March 5, 2001

**SAFETY REVIEW
OF THE
HANFORD SPENT NUCLEAR FUEL PROJECT
DURING THE
DESIGN AND CONSTRUCTION PHASE**

**Defense Nuclear Facilities Safety Board
Technical Report**

February 2001

**Figure 3-
Storage
Newmark
Response**

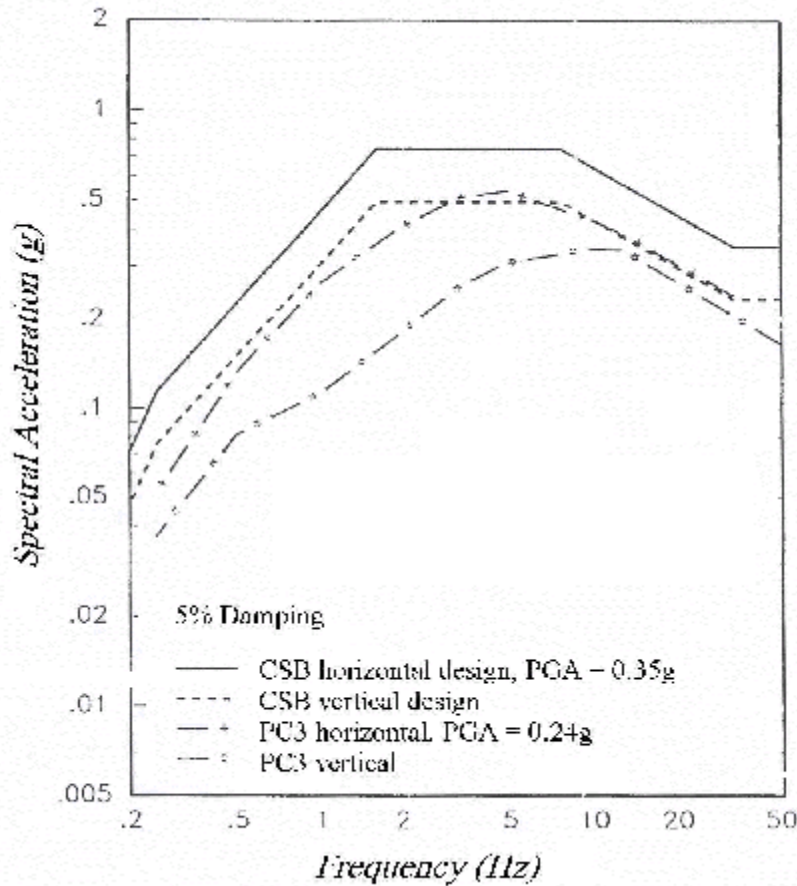
- ! The seismic excitation of the significantly embedded substructure was initially analyzed using a new, unverified computer code that is not able to account for soil-structure interaction effects directly. A more appropriate code was subsequently used for analysis of soil-structure interaction. The Board's staff performed its own analysis of how the seismic input motion is transmitted to the relatively rigid below-ground structure. As a result of discussions between the staff and SNFP personnel, the contractor made adjustments to the final in-structure response spectra. The in-structure response spectra are used for the design and qualification of equipment and components.

The issue of nuclear safety equivalency with NRC requirements was not fully achieved. When NRC requirements were not considered to be cost-effective, alternative design criteria were selected, consistent with the DOE policy. For example, even though seismic loads are the only significant loads considered in the CSB design, an exception was taken to the requirements of Appendix A to Part 100, *Seismic and Geologic Siting Criteria for Nuclear Power Plants*, 10 CFR (National Archives and Records Administration, 1999). Similarly, an exception was taken to the NRC requirements for protection against tornado missiles, based on probabilistic arguments. Although the NRC nuclear safety equivalency achieved was incomplete, the extent to which it was achieved was identified and justified by the project. Despite the anomalies, the Board considers that DOE Orders and standards provide an adequate basis for design of this facility.

The safety-class SSCs are designed using the seismic design spectrum specified in NUREG/CR-0098, *Development of Criteria for Seismic Review of Selected Nuclear Power Plants* (U.S. Nuclear Regulatory Commission, 1978), with the peak ground acceleration fixed at 0.35 times the acceleration due to the force of gravity. The design is considered sufficiently conservative since, in general, this spectrum is about 1.5 times more intense than the latest PC-3 site spectrum, and a PC-3 seismic design spectrum is generally acceptable for a Hazard Category 2 facility such as the CSB. The selected seismic design spectrum was the design requirement for the canceled HWVP. Since part of the below-ground structure was already constructed, it was deemed prudent to complete the design using the original HWVP design spectrum. A comparison of these spectra is shown in Figure 3-2.
